Finalisation of the renovation works

D 3.7

Project acronym	DREEAM
Grant agreement number	680511
Project title	Demonstration of an integrated Renovation approach for Energy Efficiency At the Multi building scale

Title	Finalisation of the renovation works
Version	1.0
Release date	06.09.2019
Work package	WP 3
Dissemination level	P

Figure 21. Inverter for the PV panels (left) and ventilation unit (right)

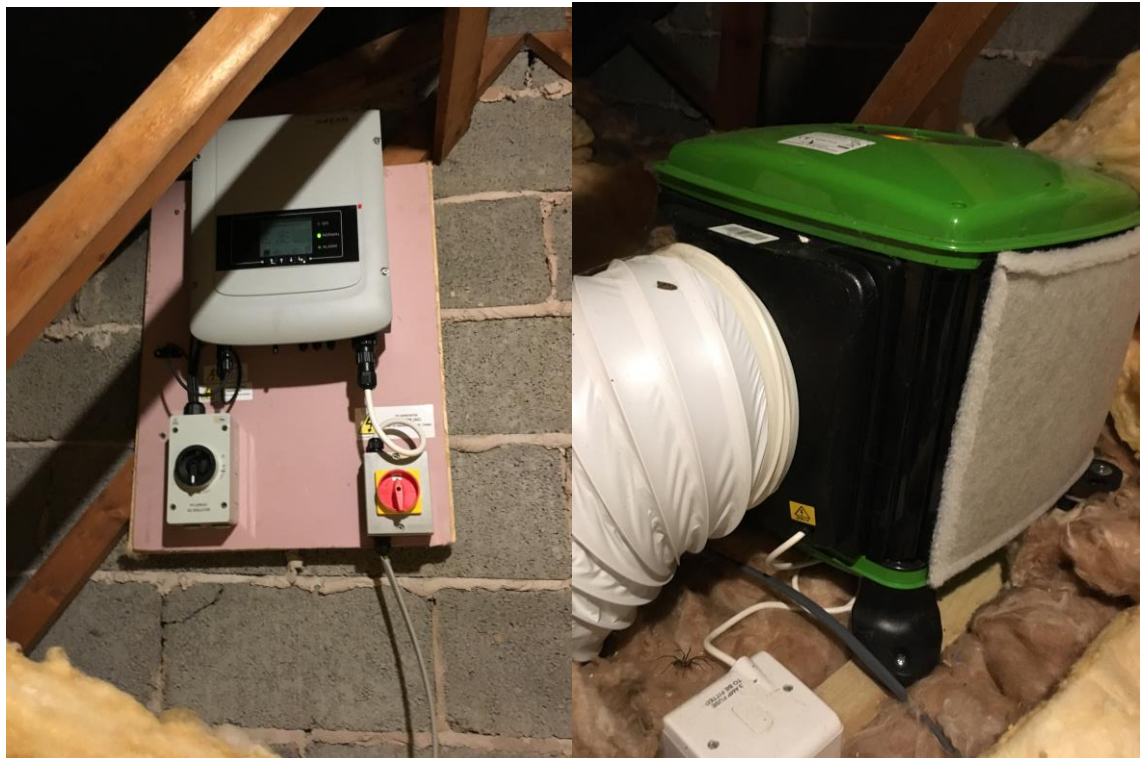
The mechanical ventilation system installed in the cold attic was working properly and as far as we could see the ducting was installed correctly so that the loose insulation is not blocking the air intake and the sealing was done correctly. In the same cold attic, the inverter for the photovoltaic panels was installed, as shown in the figures below.

Figure 24. Some neighbours have rediscovered the pleasure of keeping a blooming garden. The flooring in the right picture was done as in-kind contribution by the contractor, under request from the tenant.

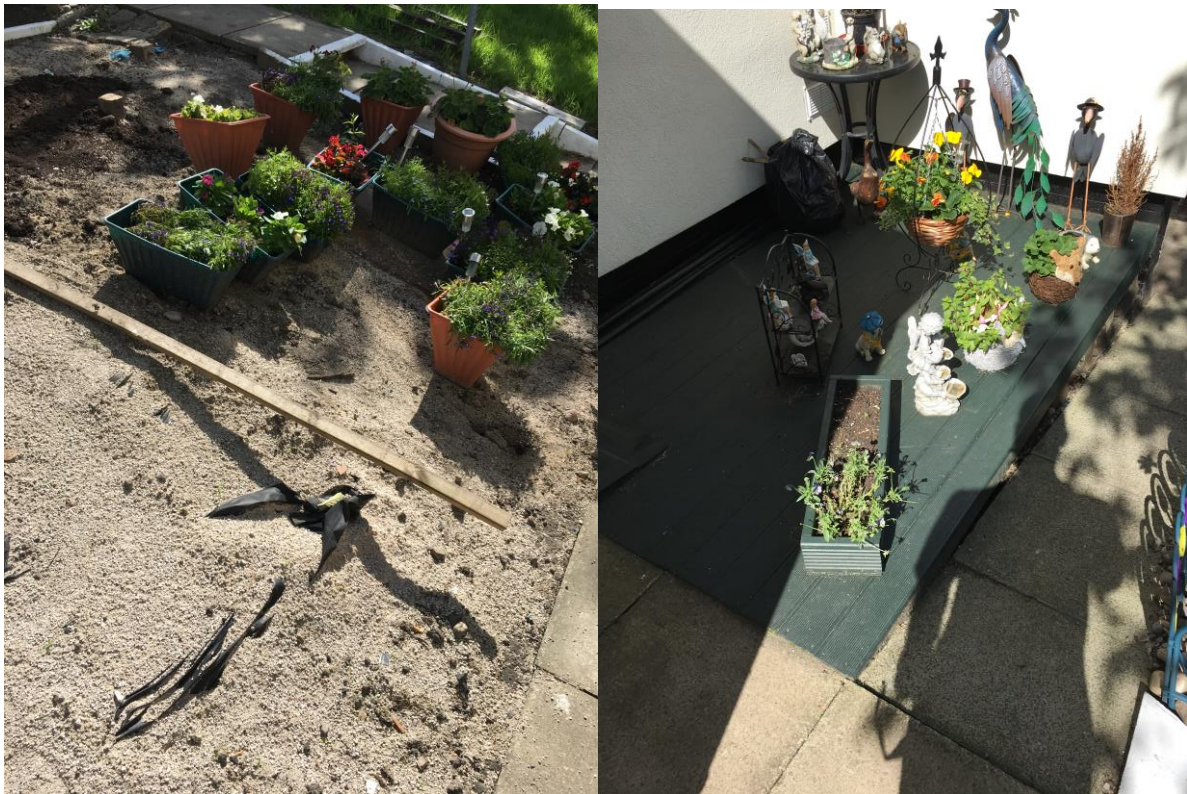
in case they have any complaints or remark, without going through the call centre: this is a strategy that worked especially with “difficult” tenants that prefer to rely on a personal relationship with the housing association. Mr. Patel told us that the contractors agreed to put some in-kind input to perform some little additional works on the tenants’ request, a sign that now tenants are caring more for their renovated houses and take pride in making it look good. One example is that people are now doing more gardening, as shown in the picture below (taken with the tenants’ permission). Improving the housing conditions is therefore an excellent way to tackle social isolation and the starting point to begin solving some of the problems that nowadays affect troubled suburbs.

Figure 37. Raised floor after polystyrene insulation

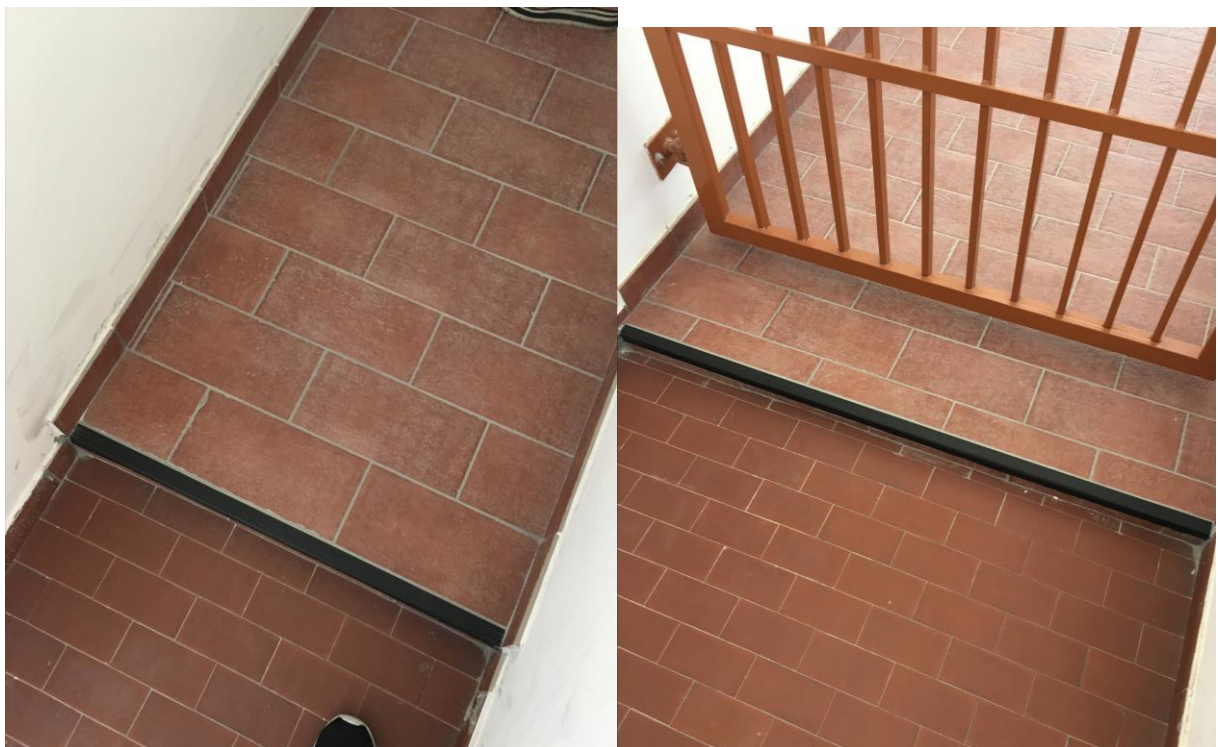
The floor of the warm attic (the room where clothes are hung to dry) was insulated as well with a layer of polystyrene, as the small step reveals the now slightly raised floor, shown in the figure below.

- *Make the attic slab as airtight as possible when insulating it to prevent warm moist air from the lower floors from getting into the common room*

The mineral wool mattresses were rolled out so that they cover all of the cold attic. The sealing around the polystyrene insulation on the floor of the warm attic is airtight. No airtightness tests were performed, only visual checks.
